CONSUMERS POWER COMPANY

PALISADES PLANT

APPENDIX A
TO
PROVISIONAL OPERATING LICENSE DPR-20
TECHNICAL SPECIFICATIONS
FOR THE
PALISADES PLANT
CONSUMERS POWER COMPANY
DOCKET NO 50-255

ERRATA SHEET NO. 1

Figure
3-1

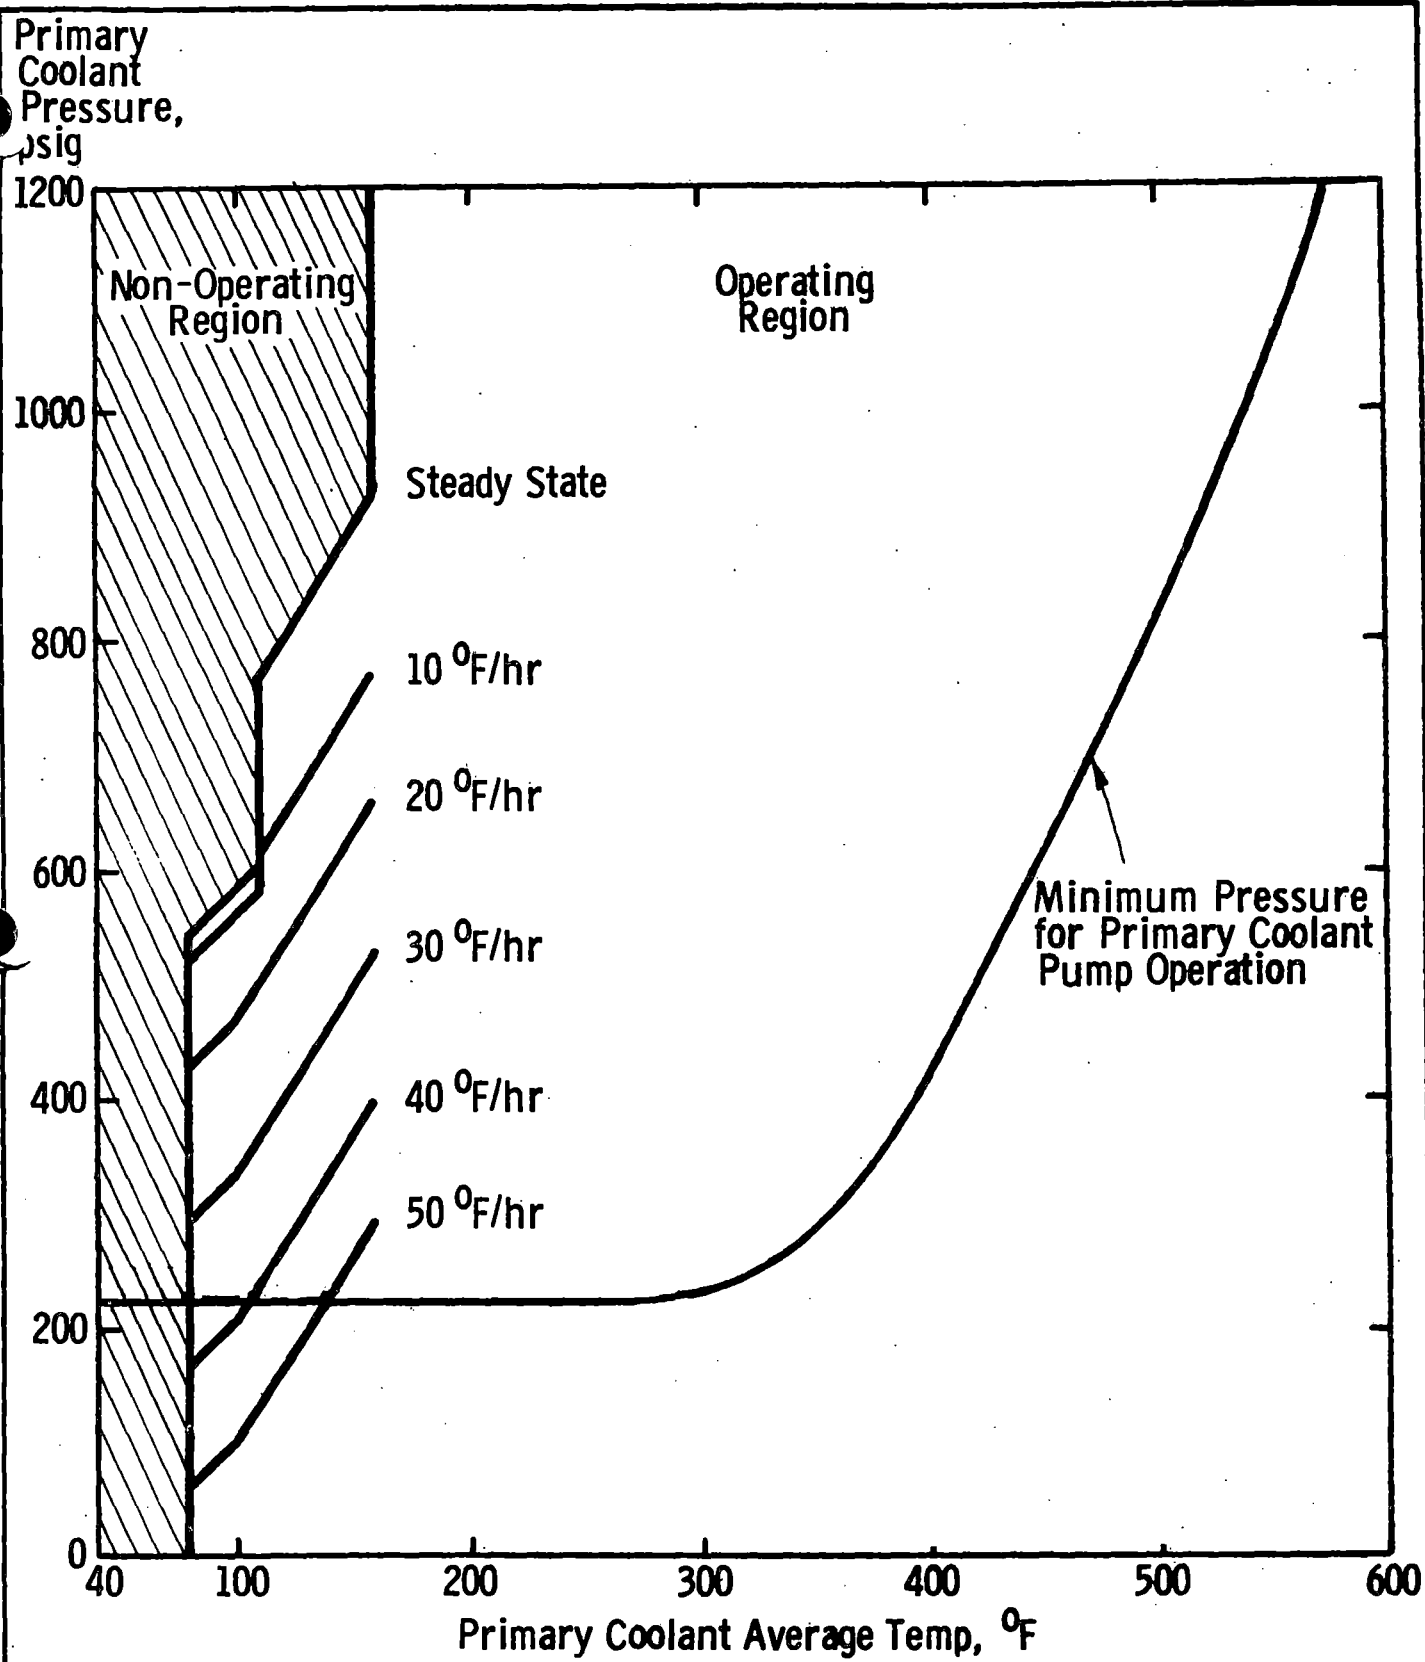
| pg. 3-8a, Fig. 3-1 | - Delete notation "Rev 1/70". |

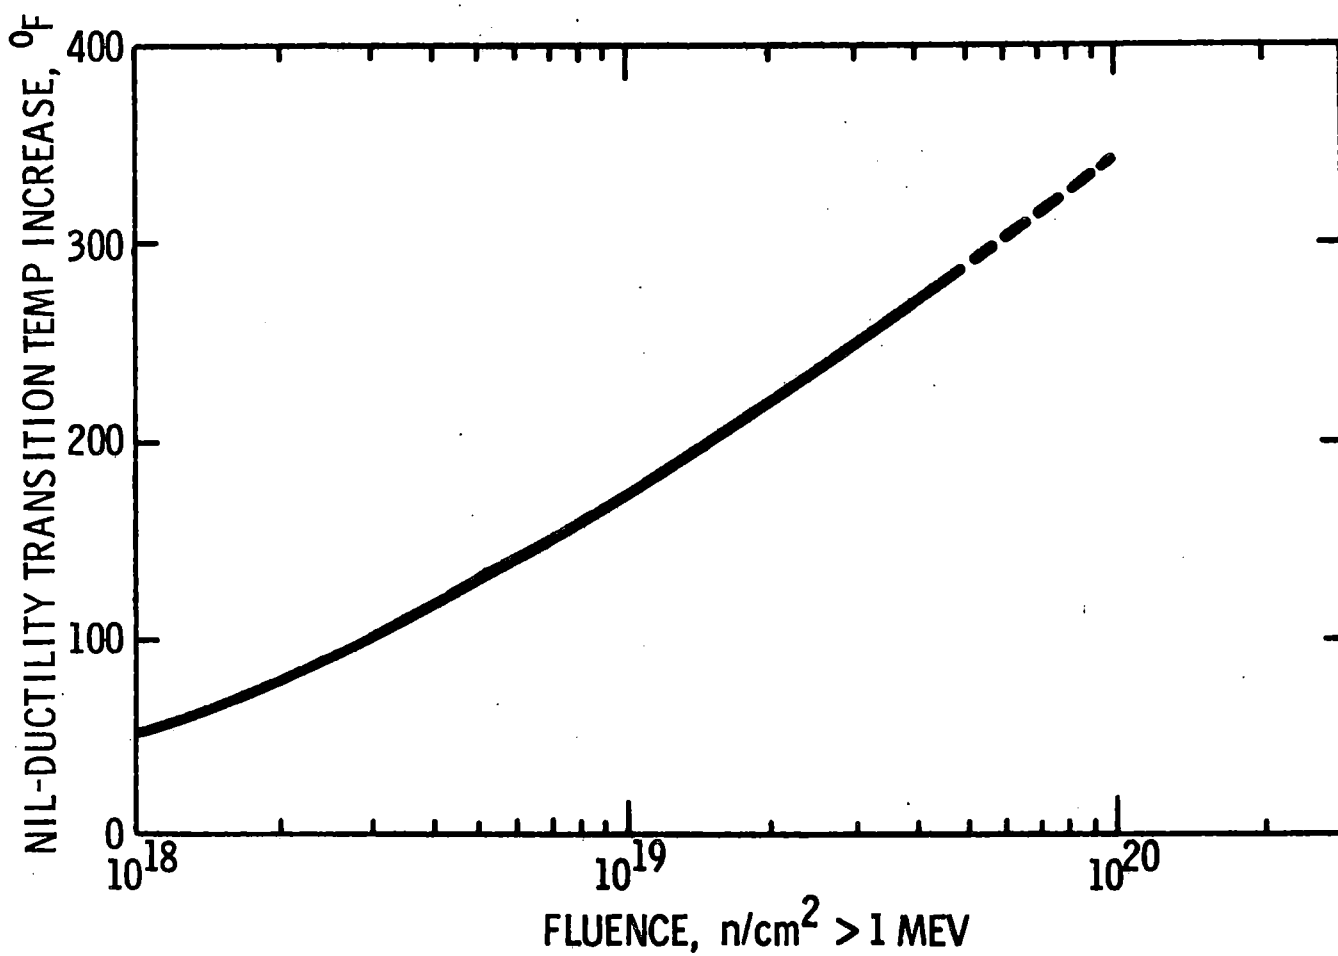
| pg. 3-8b, Fig. 3-2 | - Delete notation "Rev 1/70". |
